Nemrac Design Ltd.

Plot: A-172, BSCIC I/A, Shanshongaon, Fatullah, Narayanganj.

8th & 23rd December 2019

Observations

Column found to be stressed above normal design limits

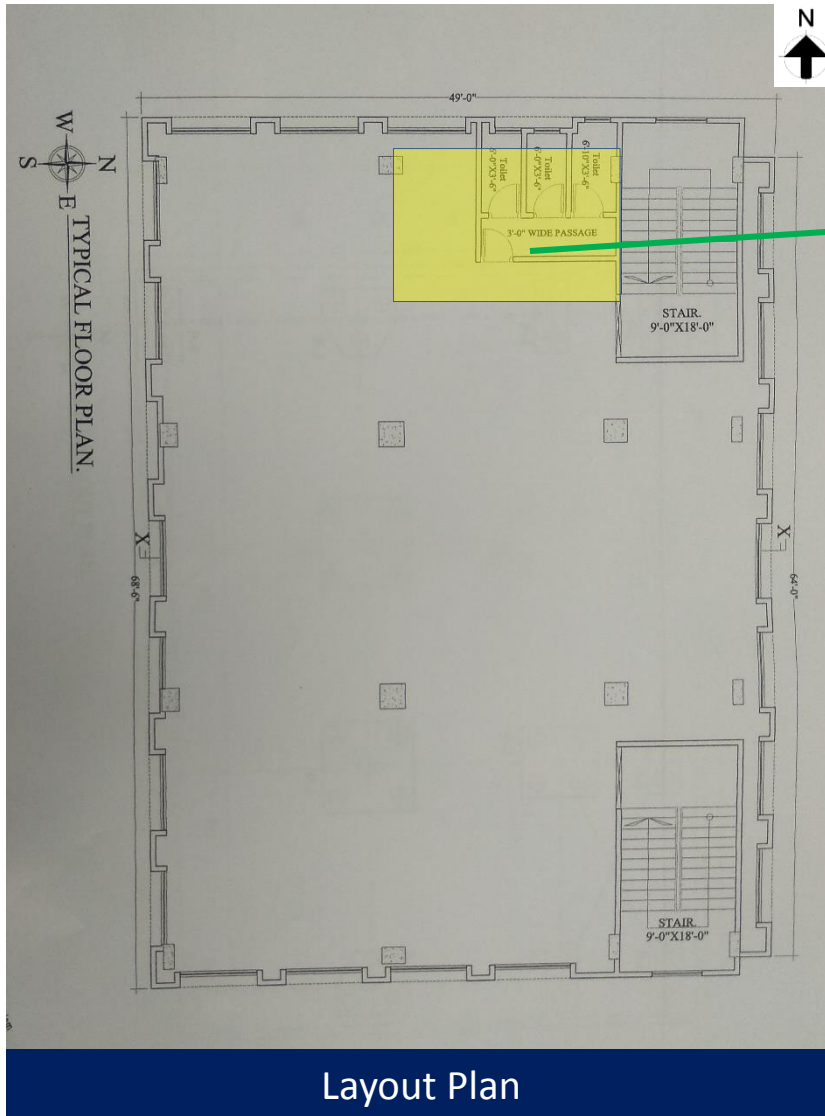
Cursory calculations indicate that the working stress of the columns at Ground Floor level are above normal design limits.

Item No.	Observation	Recommended Action Plan	Recommended Timeline
1	Column found to be stressed above normal design limits	Factory Engineer to review design, loads and columns stresses.	6-weeks
2	Column found to be stressed above normal design limits	Verify in-situ concrete stresses by 100mm dia. cores from min. 4 no. column from ground floor level.	6-weeks
3	Column found to be stressed above normal design limits	Produce and actively manage a loading plan for all floor plates considering floor capacity and column capacity.	6-weeks
4	Column found to be stressed above normal design limits	Make any structural alterations as advised by Building Engineer.	6-months
5	Column found to be stressed above normal design limits	Continue to implement loading plan.	6-months
6	Discrepancies between provided drawings and on-site condition	Building Engineer to survey the structure and prepare accurate as-built (both architectural & structural) drawings.	6-weeks

Layout Plan

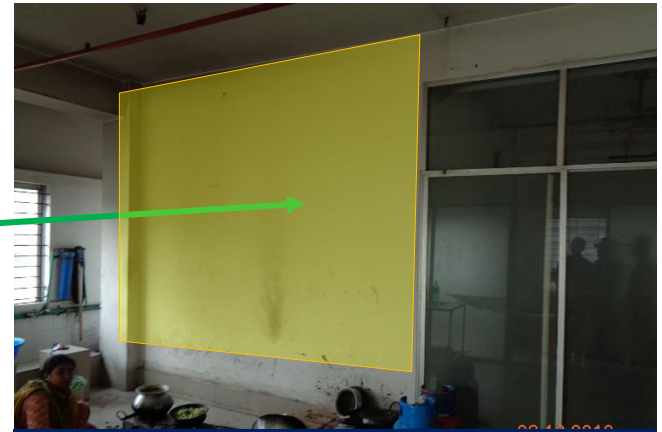
Number of rebar of C8 type column does not match with column schedule. 24 nos of rebar were shown in column schedule whereas 16 nos of rebar were found by ferro scanning. Moreover, architectural drawings did not fully match with as built condition.

New columns are marked as yellow on drawing

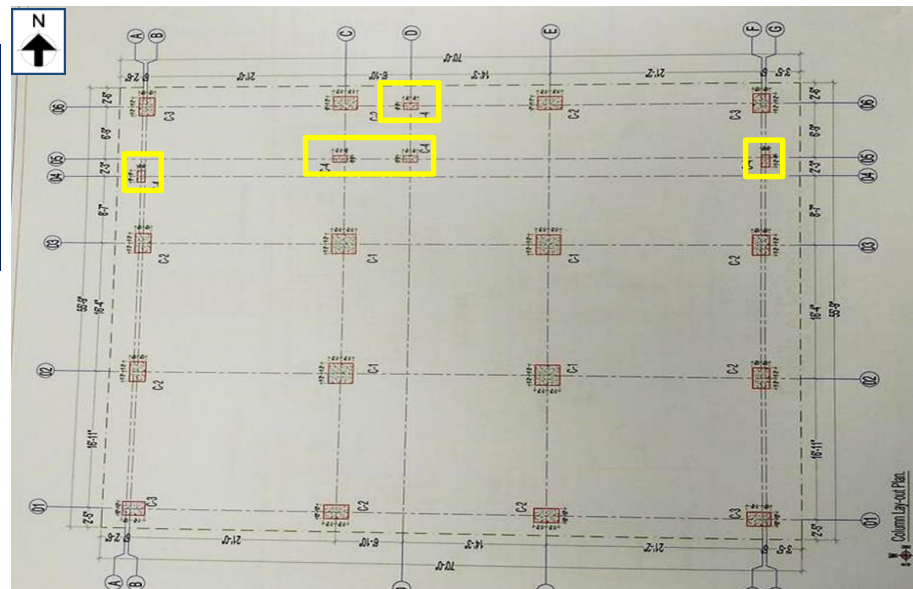
Factory has carried out retrofitting up to first floor of all columns. But no design drawings were available during inspection for retrofitting works.

Some new columns have been installed but the connection with existing beam up to 1st floor is not monolithic. Factory engineer is required to check the adequacy of the connection and suggest proper remedial measures.

Item No.	Observation	Recommended Action Plan	Recommended Timeline
12	Undocumented retrofitting works and improper connection between beam column joint	Proper retrofitting drawings & design required to be prepared and submitted to Accord for further review.	6-weeks
13	Undocumented retrofitting works and improper connection between beam column joint	Factory engineer is required to check the adequacy of the connection and suggest proper remedial measures.	6-weeks
14	Undocumented retrofitting works and improper connection between beam column joint	Carry out remedial works if required.	6-months
15	Prepared load plan does not comply with BNBC	Implement floor load management program considering 3 kPa floor live load on typical floors.	6-weeks
16	Prepared load plan does not comply with BNBC	If the floor loading is considered more than 3 kPa on suspended floors an Engineering Assessment is required to be prepared to review the design of column and floor capacity.	6-weeks

Observed floor loading

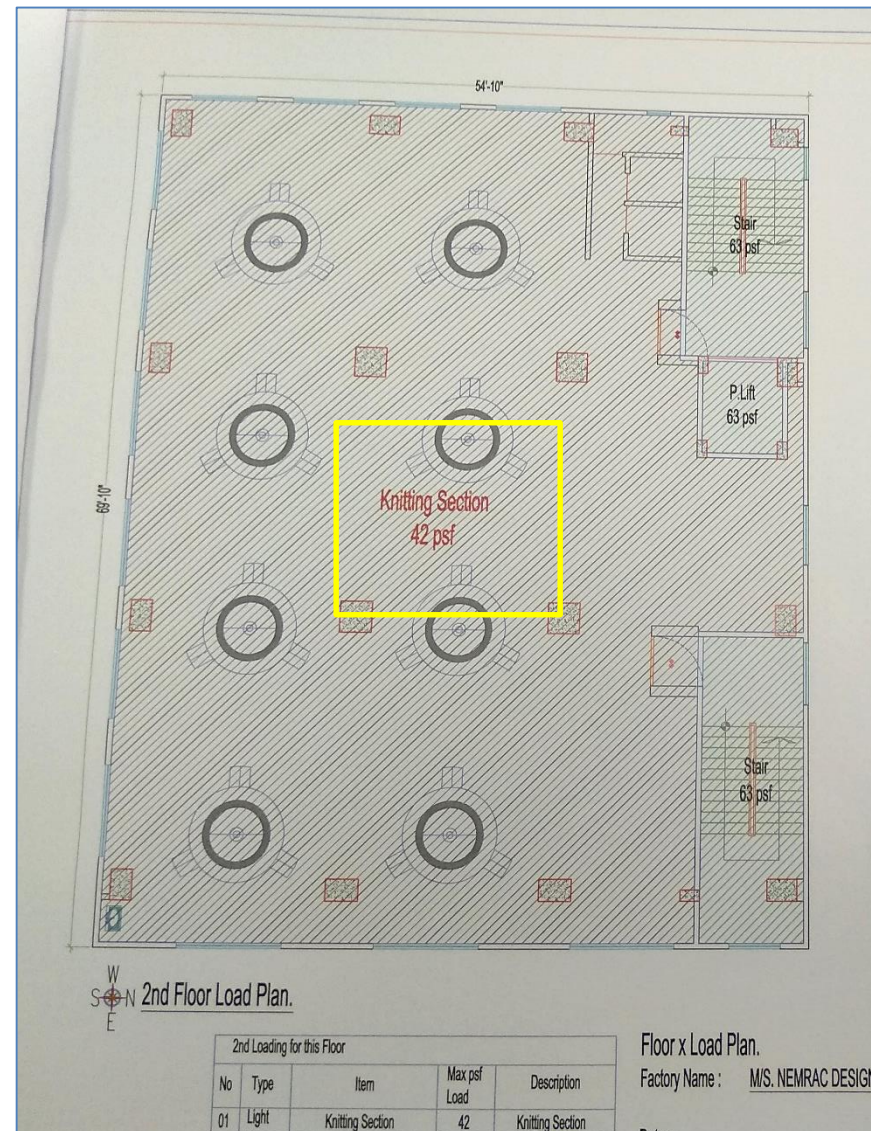
Prepared load plan does not comply with BNBC. Factory is required to revise the load plan that comply with the BNBC minimum requirement.

During inspection over loading wasn't found. Factor of Safety calculation for internal & external columns were found satisfactory considering 3kPa allowable floor live loading for the building.

17	Prepared load plan does not comply with BNBC	Continue to implement loading plan.	6-months
